Response to Information Request

Development Application for Material Change of Use – Multiple Dwelling (4 Units)

65 Stagpole Street, West End and formally identified as Lot 3 on SP338397

Information Request

DIMENSION PLAN: GROUND FLOOR - PART PLAN 2
PHASE
ISSUE FOR INSTRUCTION (IFC)
SCALE
1:100 @ A3

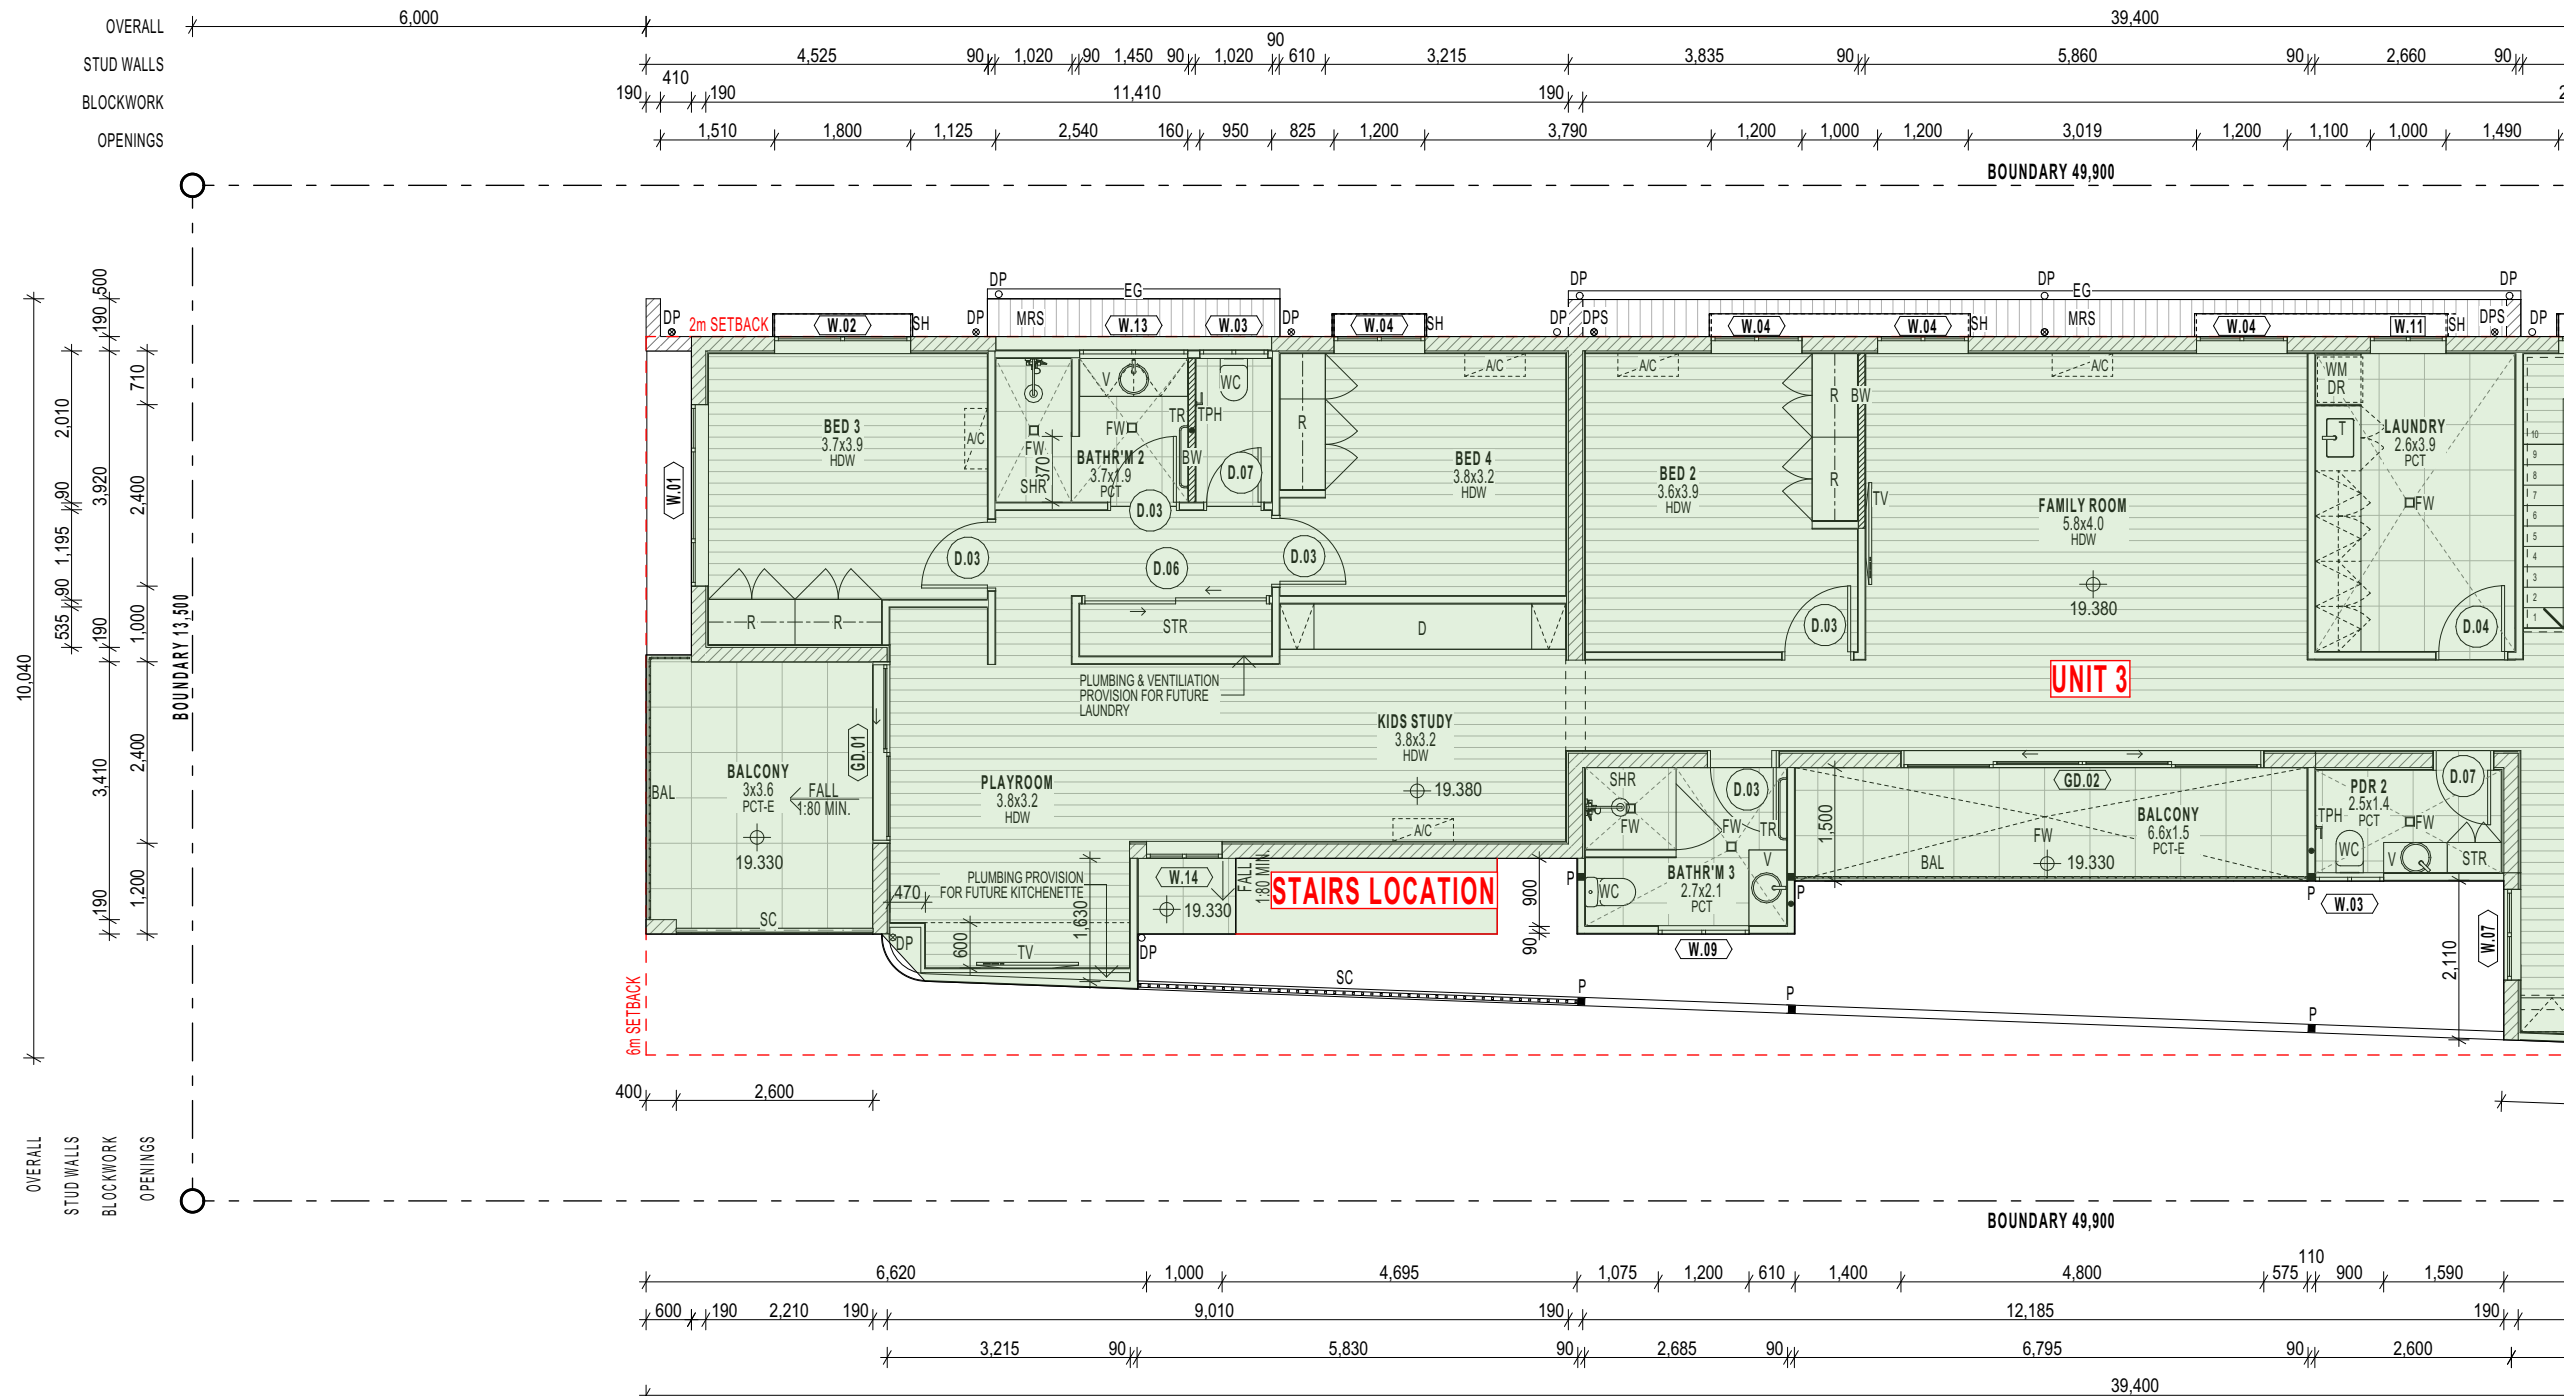
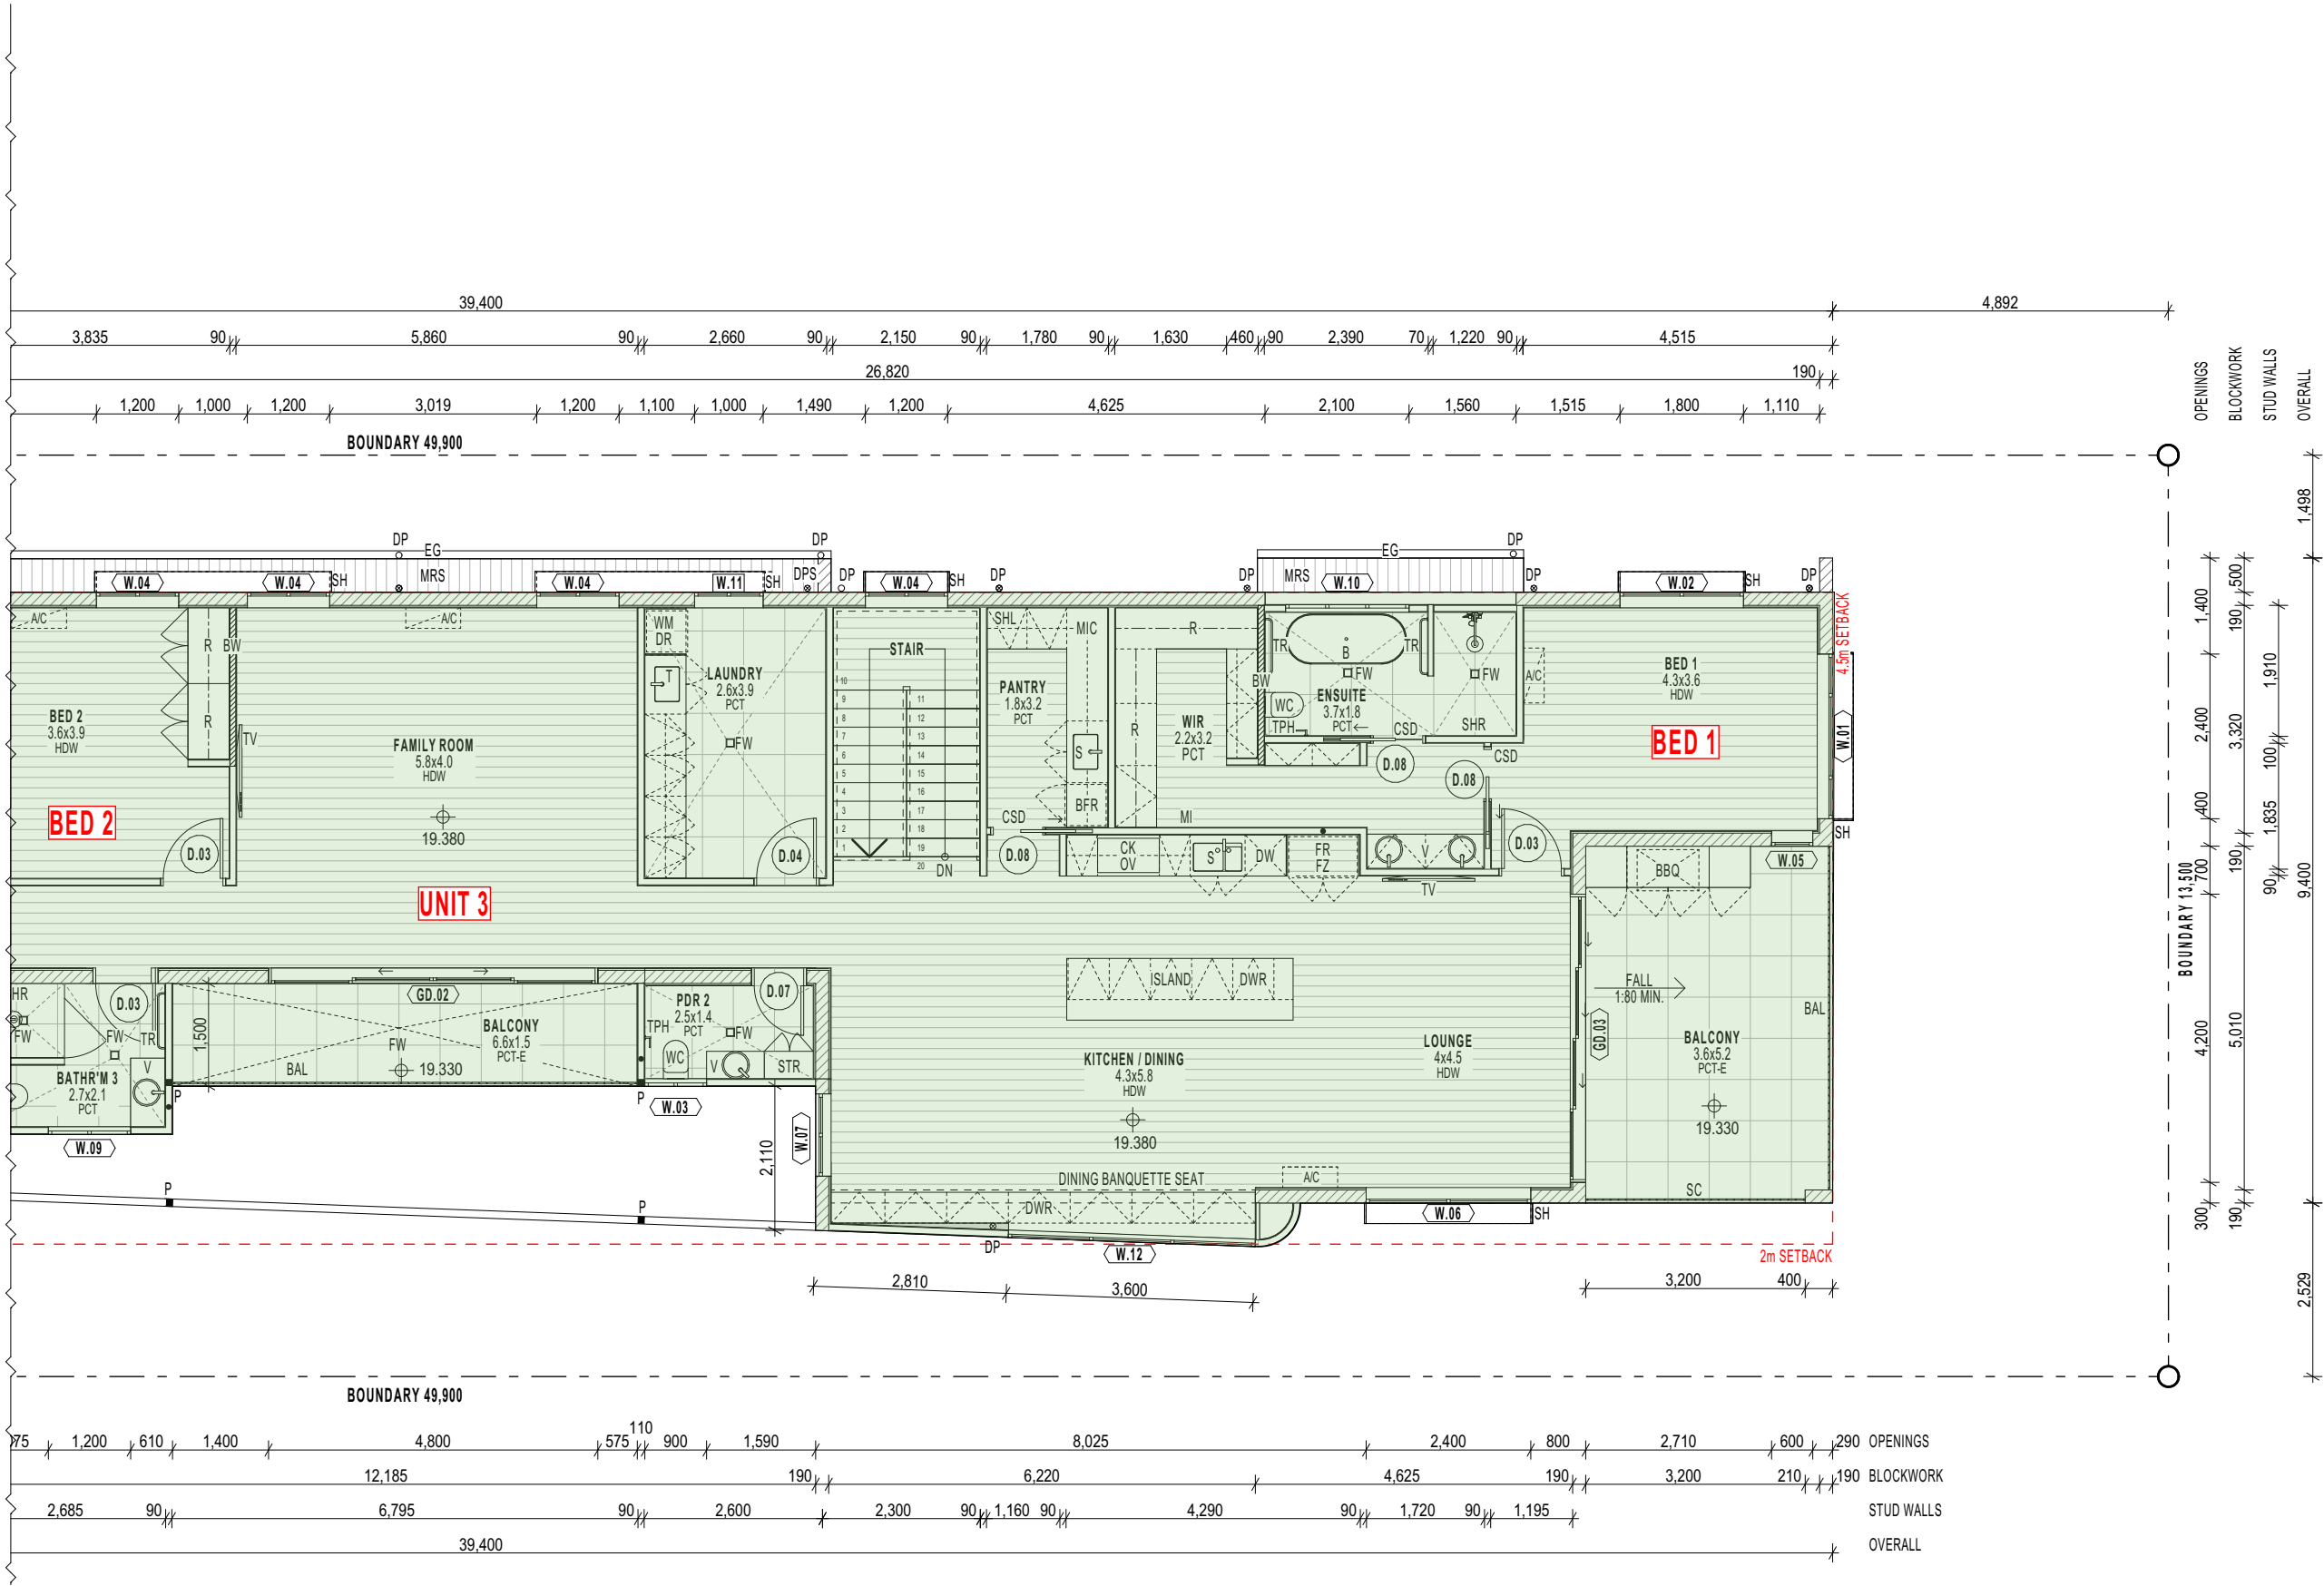
- Removal of 'Office Tayo' and 'Office Rashi' as indicated within Future Unit 1.
- Inclusion of kitchenette and laundry within Future Unit 2 to ensure the unit is self-contained.
- Enclosure/clarification on the shared wall between Future Unit 2 and Future Unit 4.
- Removal of 'Future' labelling throughout proposal plans and/or confirm timing for stages (if relevant).

In response to this item, it's confirmed that each of the requested items have been adopted and included with the amended architectural plans - refer **Attachment 2**.
